**FEDERAL AVIATION ADMINISTRATION  
AIRWORTHINESS DIRECTIVES  
SMALL AIRCRAFT, ROTORCRAFT, GLIDERS,  
BALLOONS, & AIRSHIPS**

**BIWEEKLY 2011-18**

**2011-15-11 Cessna Aircraft Company:** Amendment 39-16758; Docket No. FAA-2011-0450; Directorate Identifier 2011-CE-010-AD.

**2011-18-52 AGUSTA S.p.A (AGUSTA):** Directorate Identifier 2011-SW-055-AD.

Figure 3

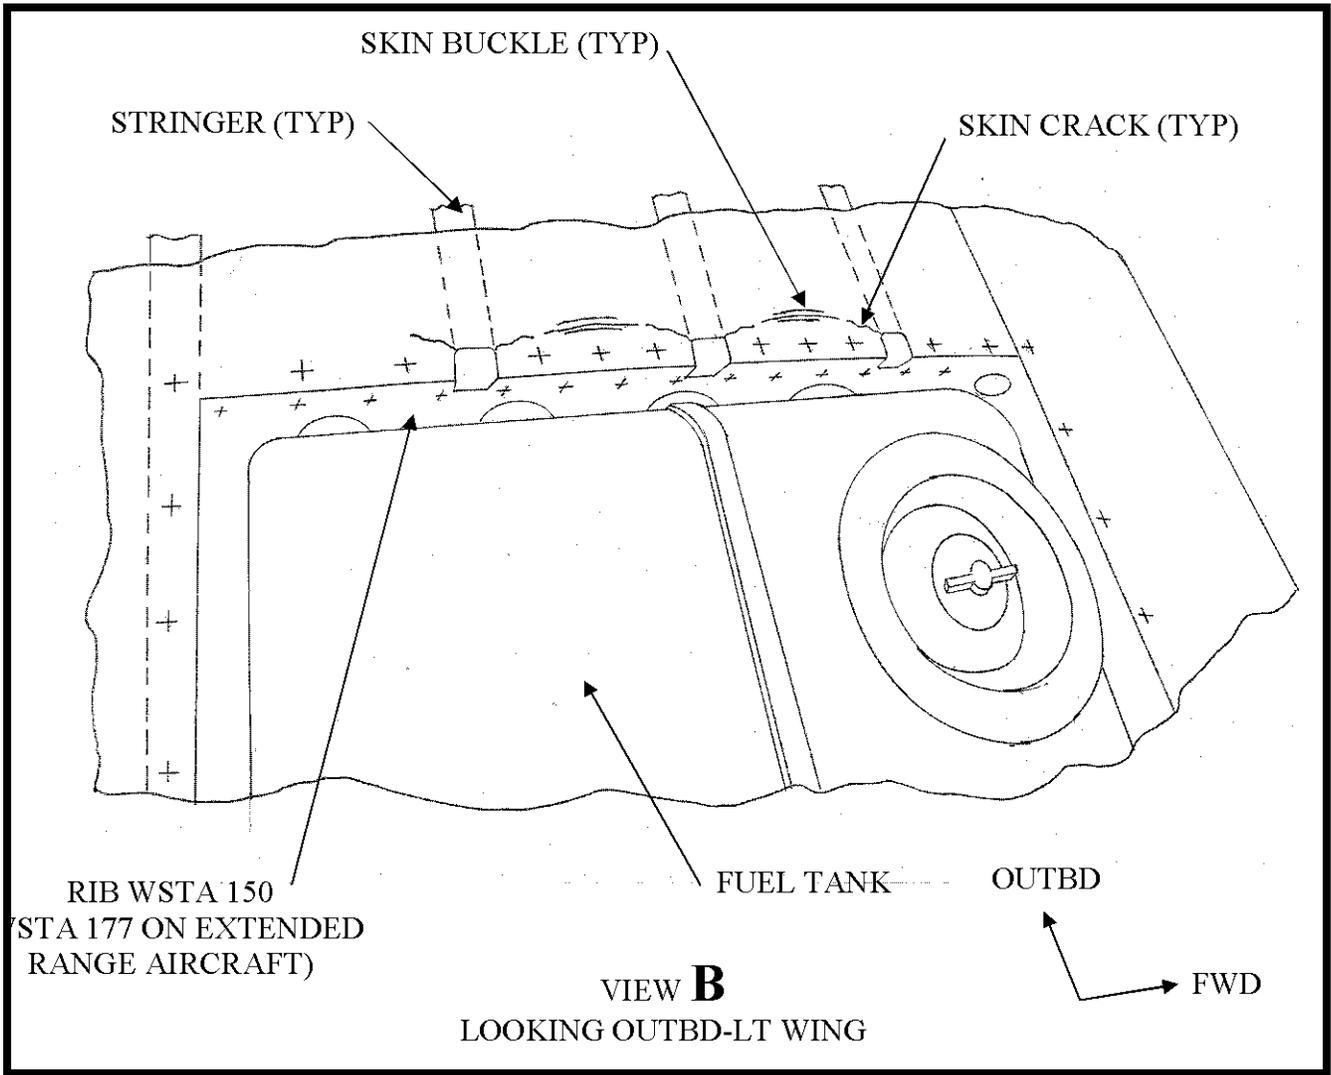
- (1) Wrinkles in upper wing skins, from the outboard edge on the fuel tank access covers (WSTA 150 or 177) to the WSTA 222 (See View B, Figure 3).
- (2) Wrinkles in the upper wing skins from WSTA 55 to 66, adjacent to the booms (See View E, Figure 6).

- (3) Cracking of the upper wing skins. Pay particular attention to any wrinkles, the radius between stiffeners at WSTA 150 (under fuel tank covers), and unreinforced access holes (See View B, Figure 3).

Figure 4

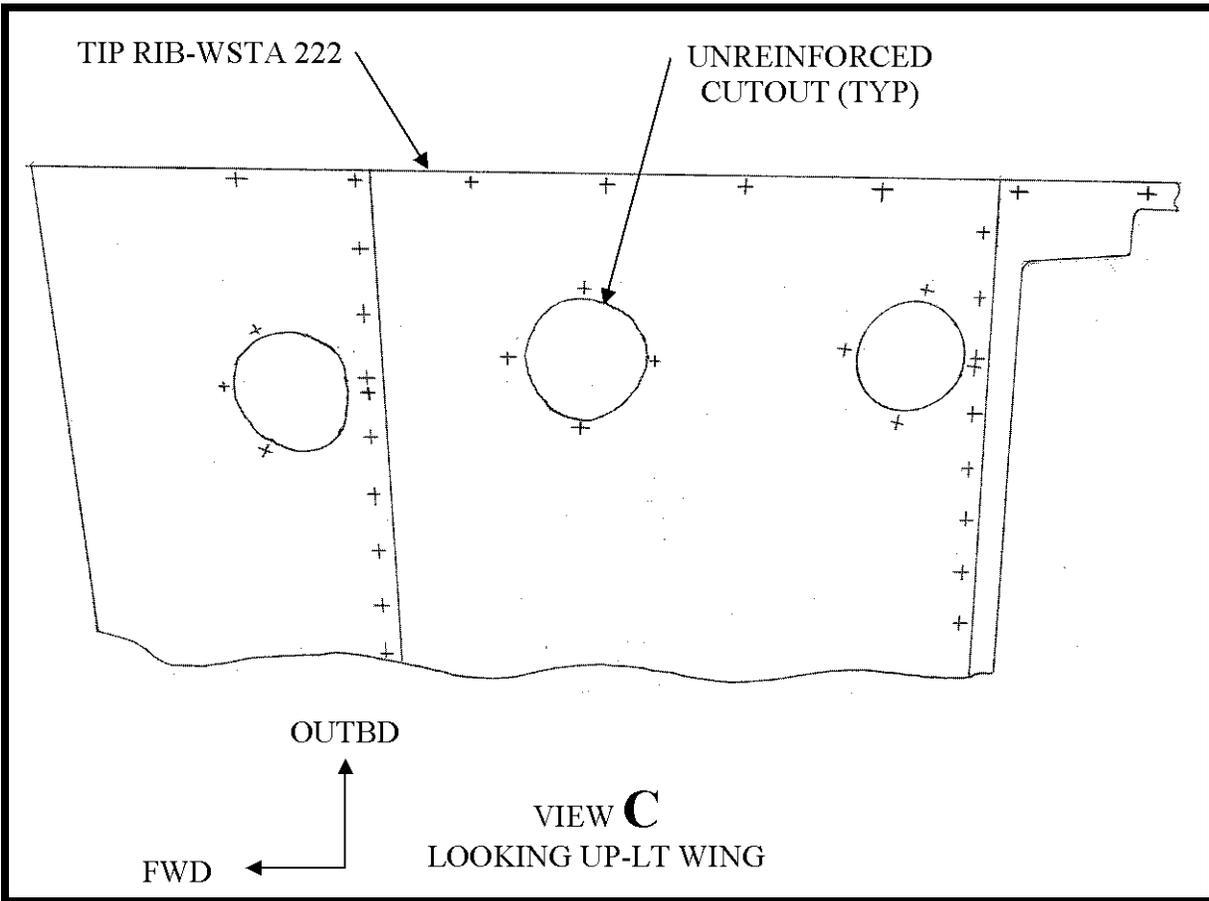
- (13) Inspect wing skins for unreinforced cutouts. (See View C, Figure 4).
- (14) Inspect the upper spar cap horizontal flanges for open holes (See View D, Figure 5).

Figure 7

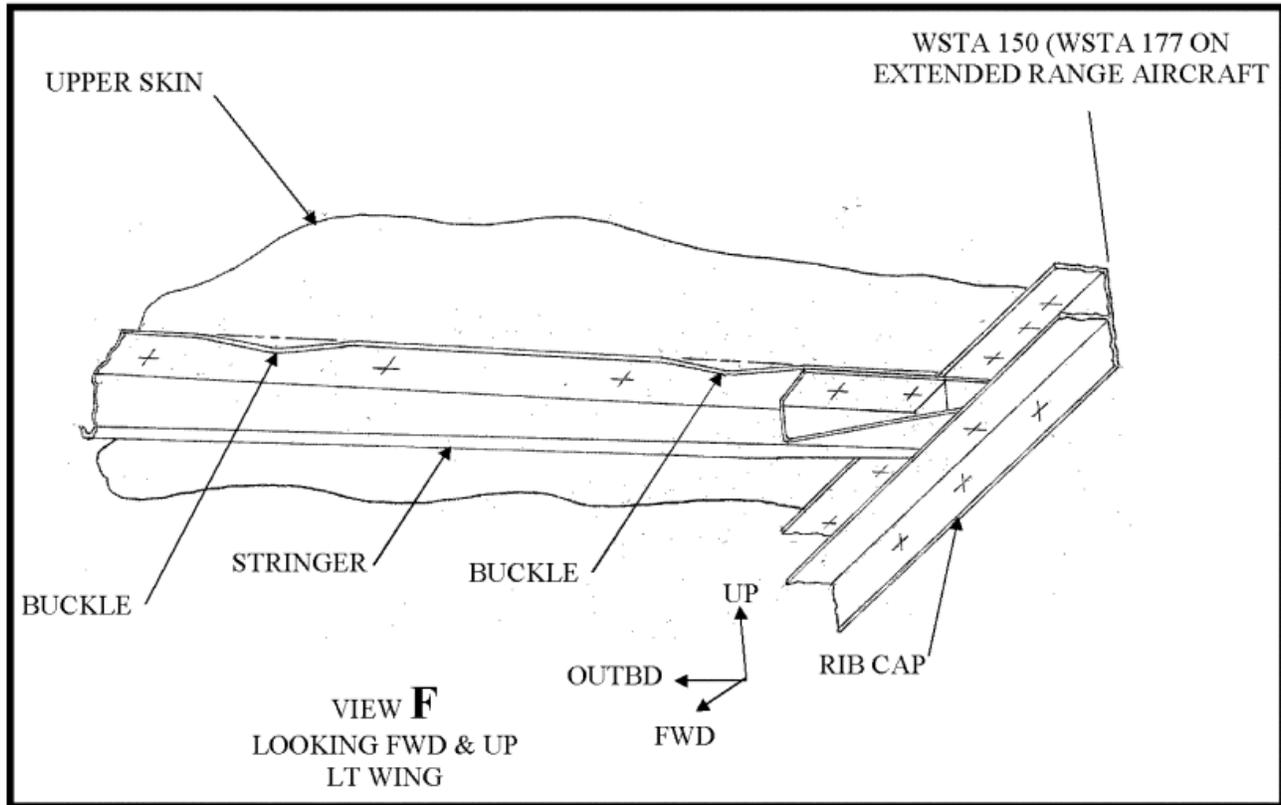
- (10) Inter-rivet buckling of the stringers attached to the upper surface skin, outboard of the fuel tank access covers (See View F, Figure 7).
- (11) Inspect rib at WSTA 222 for damage. Trimming of the rib may have been done to allow installation of fuel lines (See View A, Figure 2). Repair in accordance with AC 43.13-1B, Chapter 4, paragraph 4-58(g) and Figure 4-14, or by using another FAA-approved method that restores equivalent strength of the wing rib.

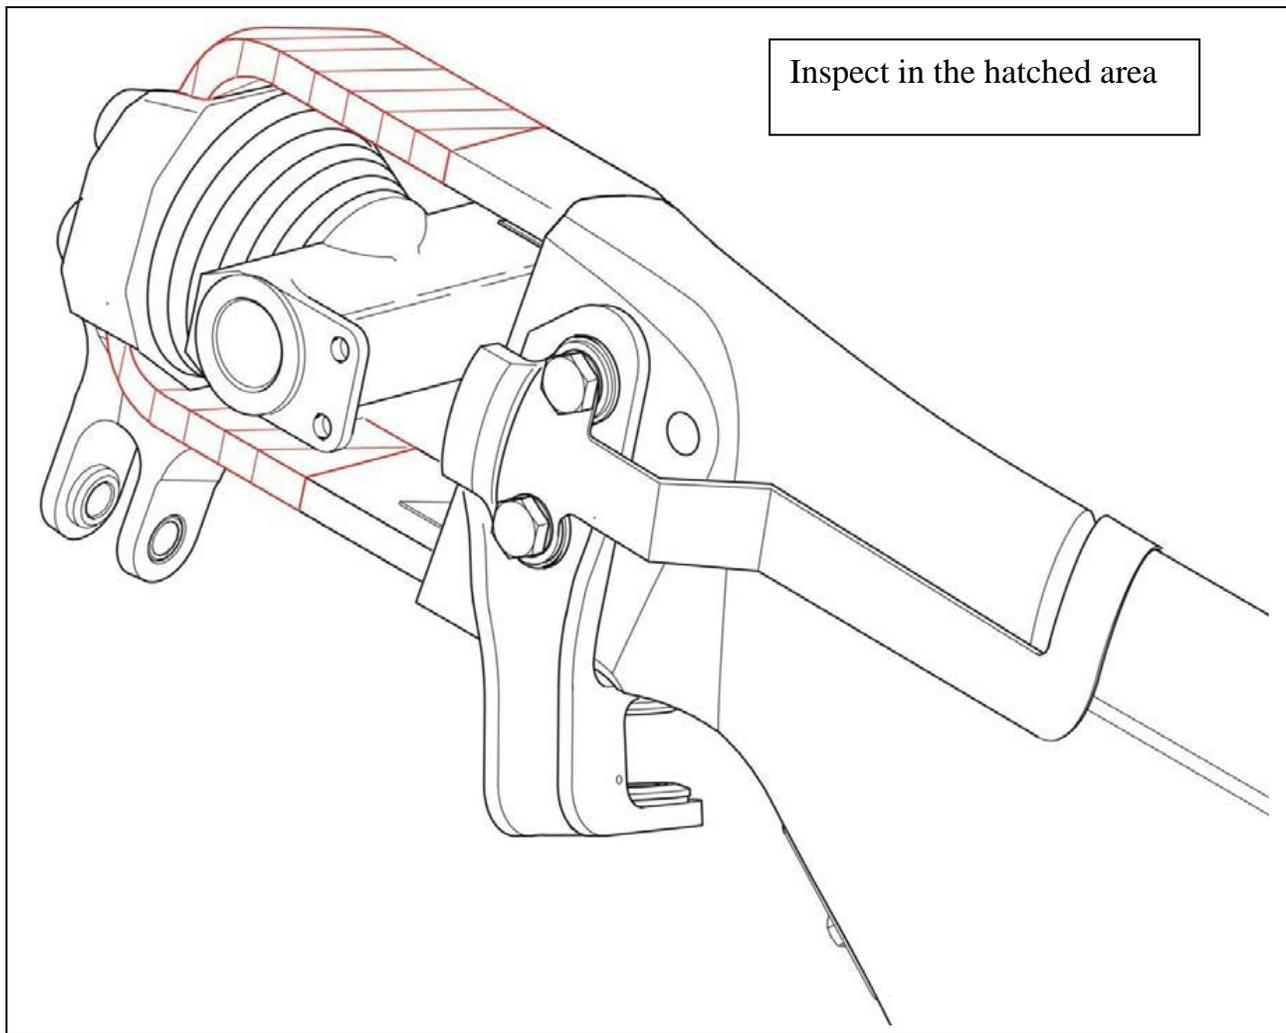
(c) Within 25 hours TIS, and thereafter at intervals not to exceed 25 hours TIS, visually inspect the T/R blade for a crack or damage that exceeds the limits of the applicable maintenance manual. Inspect in the area depicted in the following figure using a mirror, magnifying glass (5X or greater), and light source; or borescope.

- (d) If there is a crack, or if there is damage that exceeds the limits of the applicable maintenance manual, before further flight, replace the T/R blade with an airworthy T/R blade.
